Access Compliance Report

Public Rights-of-Way

(Curb Ramps)

Intersection ID: 4457	Main Street: OLD_STATESVILLE_RD	Cross Street: LABORDE_AV	Location: SW
ADA ID: E0EF721393AF	Ramp Type: Perp	Initial Pass/Fail: Fail	Overall Compliance: No
Severity Score: 21.25			
Codes/Mitigation Info/Possible Solution		Field Measurements/Component Compliance

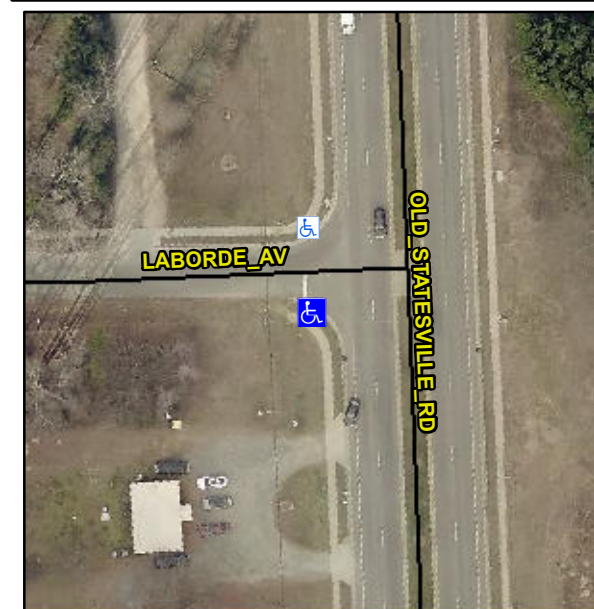
Not Found, R304.5.1, R304.2.2

Compliance	Description	Data	Compliance	Description	Data
N/A	Ramp Length (in)	59.0	No	Ramp Slope (%)	9.2
No	Ramp Width (in)	42.0	Yes	Ramp XSlope (%)	1.1
N/A	Flare Type LT	N/A	N/A	Flare Type RT	N/A
N/A	Flare Slope LT (%)	N/A	N/A	Flare Slope RT (%)	N/A
N/A	Flare Traversable LT?	N/A	N/A	Flare Traversable RT?	N/A
N/A	Landing Length (in)	N/A	N/A	DWS Provided?	N/A
N/A	Landing Width (in)	N/A	N/A	DWS Contrast?	N/A
N/A	Landing Slope (%)	N/A	N/A	DWS Length (in)	N/A
N/A	Landing X Slope (%)	N/A	N/A	DWS Full Width?	N/A
N/A	Landing Curb? (Y/N)	N/A	N/A	DWS Offset (in)	N/A
N/A	Shared Landing?	N/A			
N/A	Gutter Ponding?	N/A	N/A	Gutter Slope (%)	N/A
N/A	Gutter Lip Ht (in)	N/A	N/A	Gutter X Slope (%)	N/A
N/A	Painted X Walk1?	No	N/A	Painted X Walk2?	N/A
	X Walk 1 Direction	To N		X Walk 2 Direction	N/A
N/A	X Walk 1 Width (in)	N/A	N/A	X Walk 2 Width (in)	N/A
	X Walk 1 Slope (%)	3.2		X Walk 2 Slope (%)	N/A
	X Walk 1 X Slope (%)	4.1		X Walk 2 X Slope (%)	N/A

Remove & Replace Entire Ramp.
